GROUP Service Campaign	MODEL 2015 MY Sedona (YP) (EX, SX & SXL)
	NUMBER SC109 (REV 1, 12/19/2014)	DATE December 2014
VOLUNTARY SERVICE CAMPAIGN		
SUBJECT: SEDONA (YP) – <u>BCM</u> LOGIC REPROGRAMMING (SC109)

This bulletin provides information related to the reprogramming of the Body Control Module (BCM) of some 2015 MY Sedona (YP) vehicles (EX, SX and SXL only), produced from July 21, 2014 through November 20, 2014 to update the BCM logic for the automatic door lock feature. Kia is also providing labels for the 2015 MY Sedona Owner's Manual and a new Features and Functions Guide containing corrected automatic door lock feature information. To install the new logic, the BCM should be reprogrammed using the GDS download as described in this bulletin. Kia is requesting the completion of this Service Campaign on all affected vehicles, including dealer stock, prior to delivery. For confirmation that the latest reflash has been done to a vehicle you are working on, verify ROM ID using the tables in this TSB.

SUBJECT: SEDONA (YP) – BCM LOGIC REPROGRAMMING (SC109)

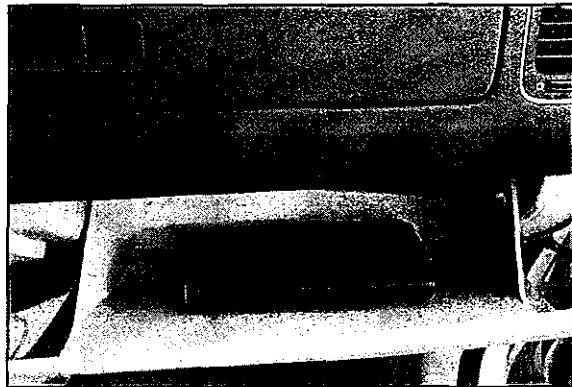
2. Open the Owner's Manual to the page shown in the table below and carefully place the corrective label over the affected text, as shown.

Page	Content to be Corrected
4-26	* NOTICE

Automatic door lock system
All doors will be automatically locked if the automatic transaxle shift lever is shifted from the P (Park) position to the R (Reverse), N (Neutral) or D (Drive) position.

Discard the original FFG and replace it with a new one (See "Required Parts" table on Page 7).
